**Packet Guide**  
**City of Charlottesville**  
**Board of Architectural Review**  
**Regular Meeting**  
**January 18, 2023, 5:30 p.m.**  
**Hybrid Meeting (In-person at CitySpace and virtual via Zoom)**

BAR # 22-09-03

1301 Wertland Street, TMP 040303000

Project: New apartment building/existing Wertenbaker House c1830

Incorrect rendering (sheet 18 of submittal;)

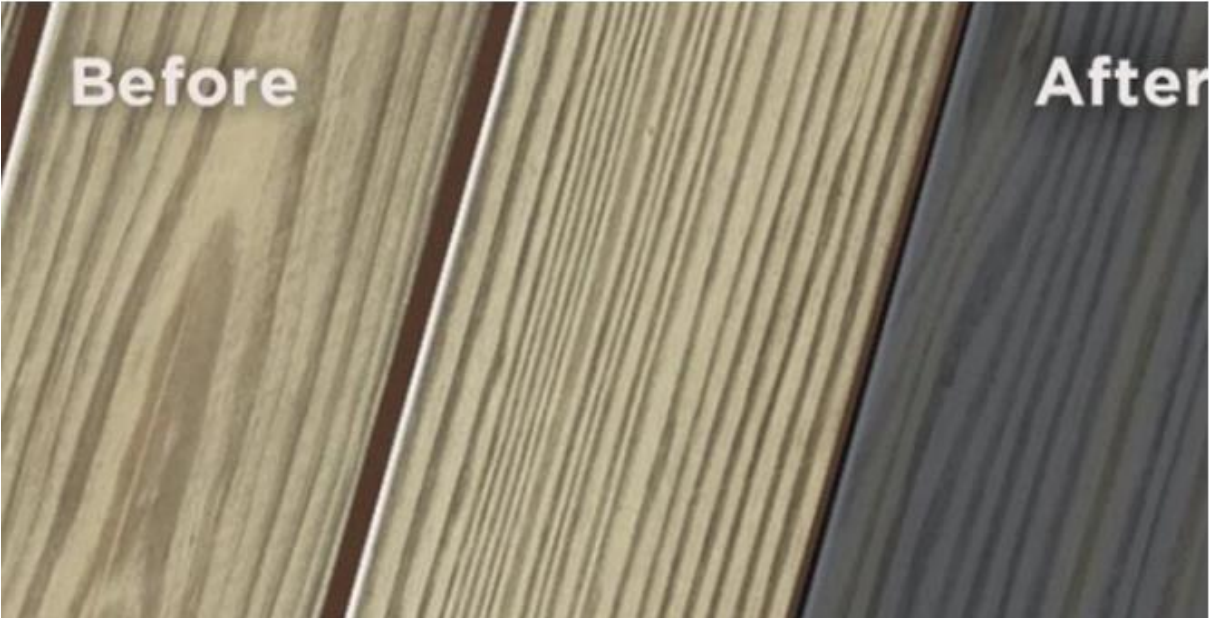
**Note:** The rendering on sheet 18 of the submittal is incorrect. Correct image is in the Appendix of this staff report.

Correct rendering

Canopy at garage entrance

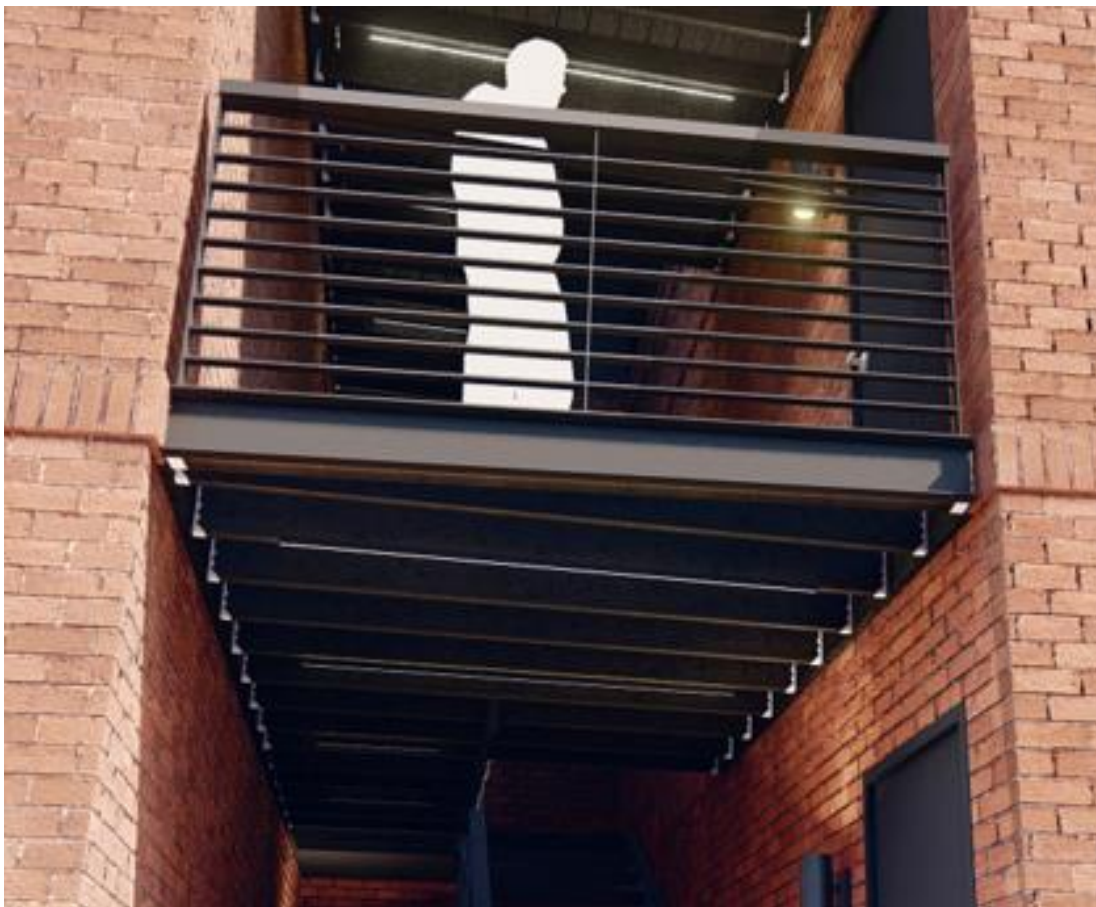
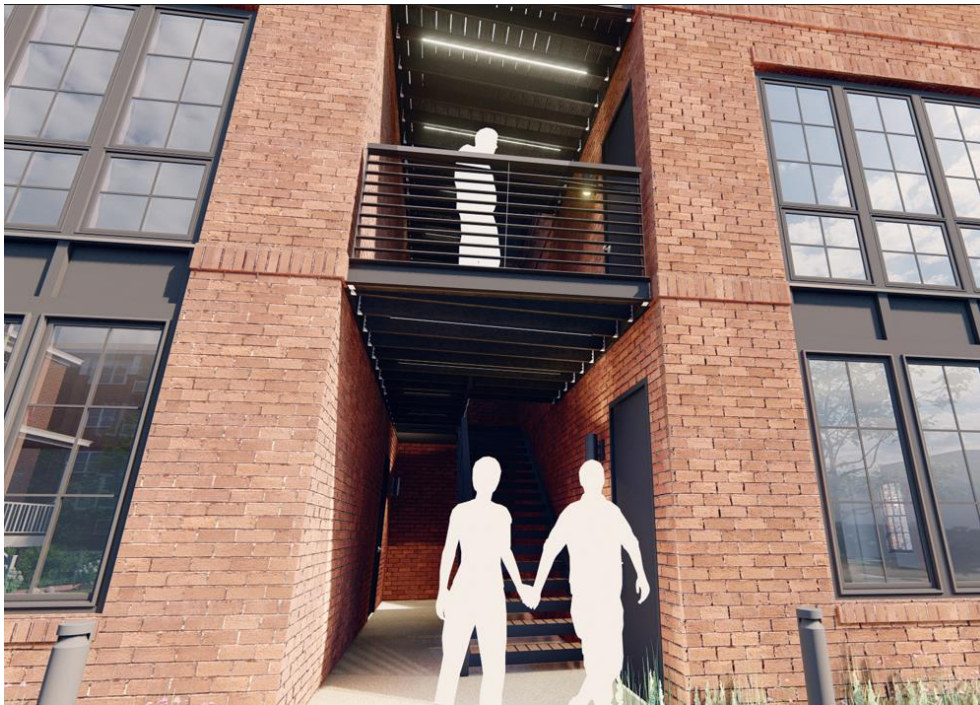
- Garage Door: None
- Canopy near garage entrance: (See image in Appendix.) Structural c-channels around the exterior (similar to balcony detail on Sheet 37). EPDM roof. Stained wood ceiling.
